TRANS/WP.29/806

World Forum for Harmonization of Vehicle Regulations (WP.29)

DRAFT SUPPLEMENT 1 TO THE 01 SERIES OF AMENDMENTS
TO REGULATION No. 94

(Frontal collision protection)

Figure 1

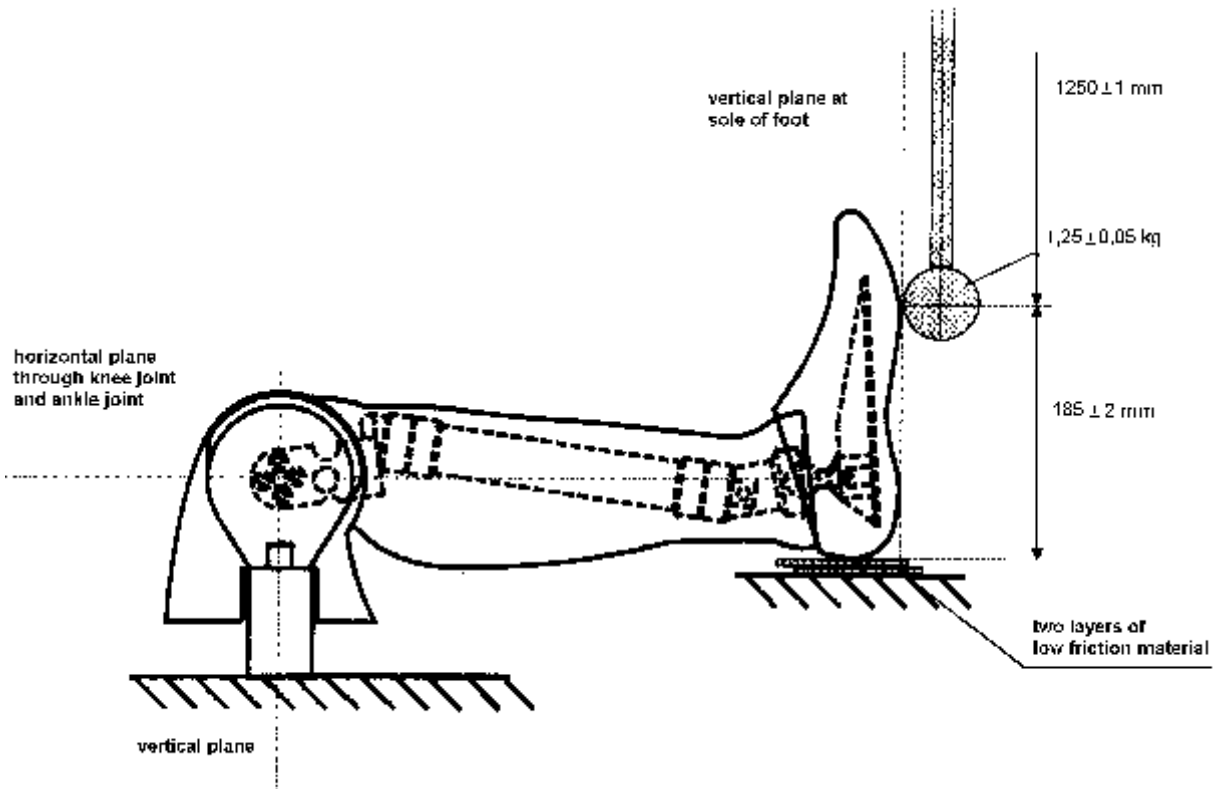
- 1.3.3. Align the impactor accelerometer with its sensitive axis parallel to the direction of impact at contact with the foot.
- 1.3.4. Mount the leg assembly to the fixture shown in Figure 1. The test fixture shall be rigidly secured to prevent movement during impact. The centre line of the femur load cell simulator (78051-319) shall be vertical with a tolerance of $\pm 0.5^\circ$. Adjust the mount such that the line joining the knee clevis joint and the ankle attachment bolt is horizontal with a tolerance of $\pm 3^\circ$, with the heel resting on two sheets of a flat low friction (PTFE sheet) surface. Ensure that the tibia flesh is located fully towards the knee end of the tibia. Adjust the ankle such that the plane of the underside of the foot is vertical and perpendicular to the direction of impact with a tolerance of $\pm 3^\circ$ and such that the mid sagittal plane of the foot is aligned with the pendulum arm. Adjust the knee joint to 1.5 ± 0.5 g range before each test. Adjust the ankle joint so that it is free and then tighten just sufficiently to keep the foot stable on the PTFE sheet.

- 1.4. Performance specification
 - 1.4.1. When each ball of the foot is impacted at $6.7 (\pm 0.1)$ m/s in accordance with paragraph 1.3., the maximum lower tibia bending momentum about the y-axis (M_y) shall be 120 ± 25 Nm.

Figure 2

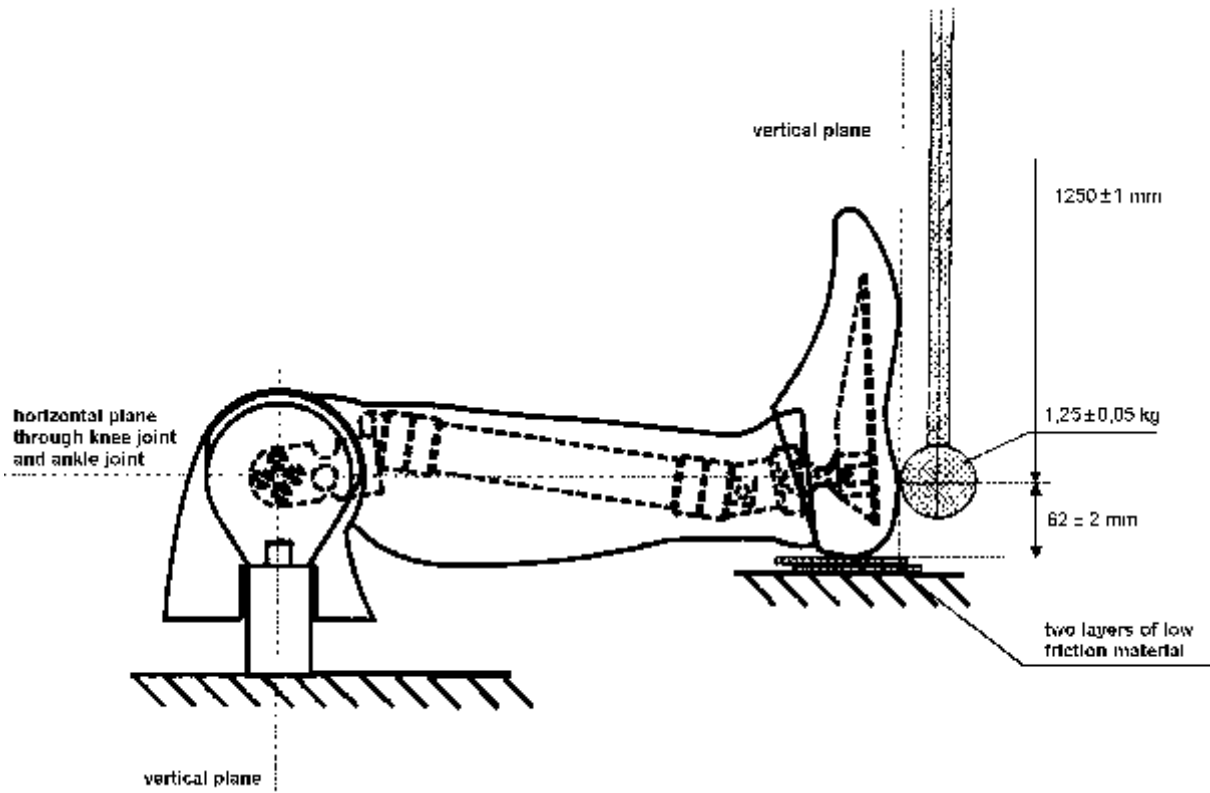
2.3.4. Mount the leg assembly to the fixture shown in Figure 2. The test fixture shall be rigidly secured to prevent movement during impact. The centre line of the femur load cell simulator (78051-319) shall be vertical with a tolerance of $\pm 0.5E$. Adjust the mount such that the line joining the knee clevis joint and the ankle attachment bolt is horizontal with a tolerance of $\pm 3E$ with the heel resting on two sheets of a flat low friction (PTFE sheet) surface. Ensure that the tibia flesh is located fully towards the knee end of the tibia. Adjust the ankle such that the plane of the underside of the foot is vertical and perpendicular to the direction of the impact with a tolerance of $\pm 3^\circ$ and such that the mid sagittal plane of the foot is aligned with the pendulum arm. Adjust the knee joint to 1.5 ± 0.5 g range before each test. Adjust the ankle joint so that it is free and then tighten just sufficiently to keep the foot stable on the PTFE sheet.

cylinder and the axis of rotation of the whole pendulum shall be 1.250 ± 1 mm. The impact cylinder is mounted with its longitudinal axis horizontal and perpendicular to the direction of impact. The pendulum shall impact the underside of the foot, at a distance of 62 ± 2 mm from the base of the heel resting on the rigid horizontal platform, so that the longitudinal centre line of the pendulum arm falls within 1° of a vertical line at impact. The impactor shall be guided to exclude significant lateral, vertical or rotational movement.

- 2.4. Performance specification
 - 2.4.1. When each heel of the foot is impacted at 4.4 ± 0.1 m/s in accordance with paragraph 2.3., the maximum impactor acceleration shall be 295 ± 50 g.

Figure 3

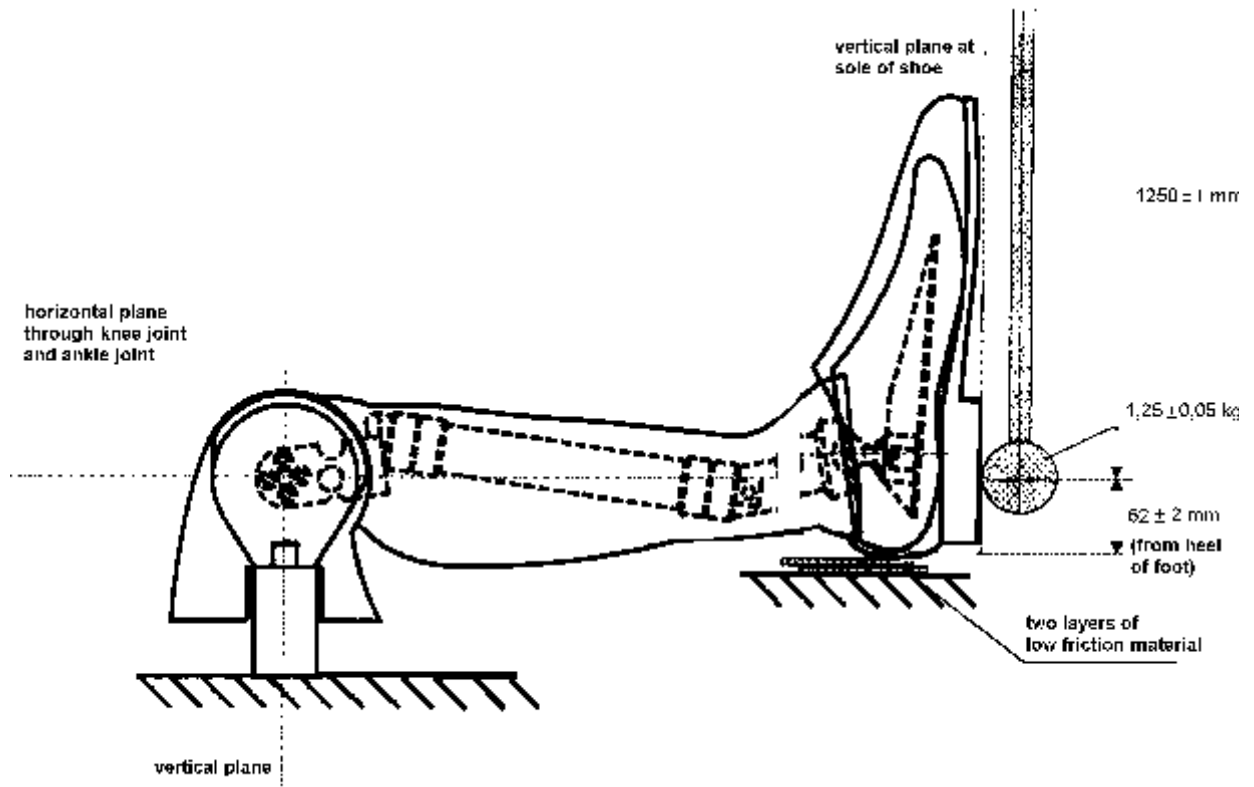
- 3.3.4. Mount the leg assembly to the fixture shown in Figure 3. The test fixture shall be rigidly secured to prevent movement during impact. The centre line of the femur load cell simulator (78051-319) shall be vertical with a tolerance of $\pm 0.5^\circ$. Adjust the mount such that the line joining the knee clevis joint and the ankle attachment bolt is horizontal with a tolerance of $\pm 3E$, with the heel of the shoe resting on two sheets of a flat low friction (PTFE sheet) surface. Ensure that the tibia flesh is located fully towards the knee end of the tibia. Adjust the ankle such that a plane in contact with the heel and sole of the underside of the shoe is vertical and perpendicular to the direction of impact with a tolerance of $\pm 3E$ and such that the mid sagittal plane of the foot, and shoe is aligned with the pendulum arm. Adjust the knee joint to 1.5 ± 0.5 g range before each test. Adjust the ankle joint so that it is free and then tighten just sufficiently to keep the foot stable on the PTFE sheet.

- 3.4. Performance specification
- 3.4.1. When the heel of the shoe is impacted at 6.7 ± 0.1 m/s in accordance with paragraph 3.3, the maximum Tibia compressive force (F_z) shall be 3.3 ± 0.5 kN.
